**ADDENDUM NO: 1**

**RFP 144429:** Video Wall System

**REASON:** Responses to All Questions as of 4:00 pm EST

16-28 CHATTANOOGA POLICE SERVICES CENTER PLAN #4  
Vendor

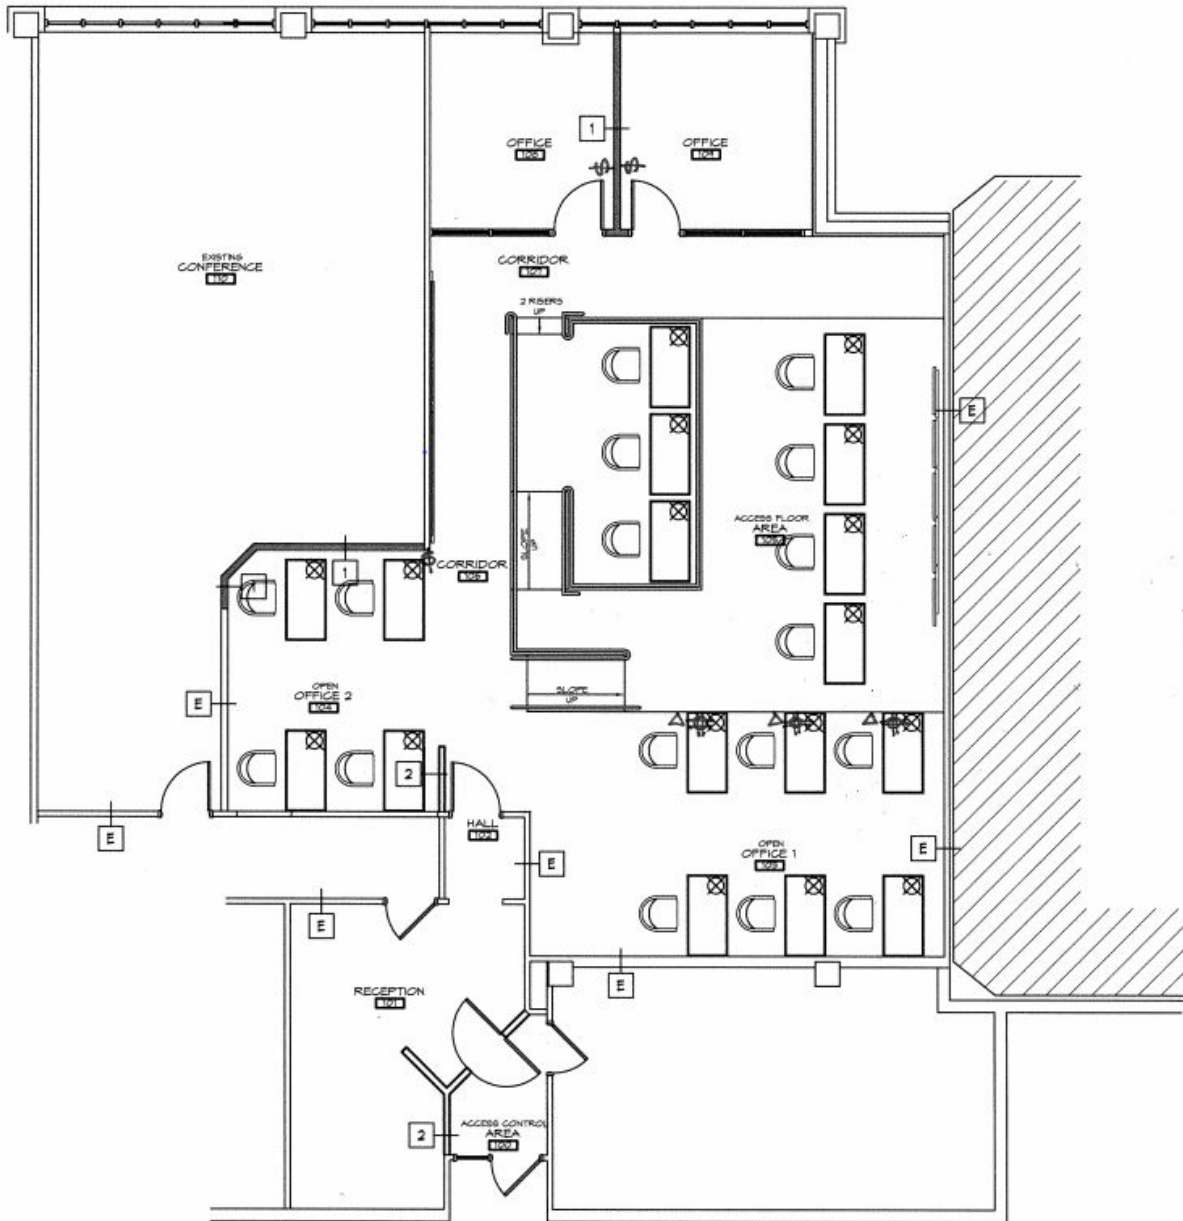
### 1. Will there be a Pre-Bid walk-thru of the space?

1. **Can we please get floor plans showing location of the video wall and video processor?**  
This has been provided.
2. **Can we please get a list of all content that will be displayed on the video wall and its corresponding source (video, IP, streaming video)?**  
This will be better defined as the project progresses. For now, cameras, news channels, analytics, security video, and weather alerts.
3. **What existing software and BI tools will interface with the video wall system?**  
Most software is still to be determined. Vendor should specify current integration with various APIs.
4. **Regarding the electrical requirements, does the cost of the electric work need to be included in the initial bid? If so, how far is an electrical panel with 40amps spare capacity from the video wall?**

No, however, we have provided the following pictures (including a blueprint of the space) in hopes of providing you enough information to submit responses.
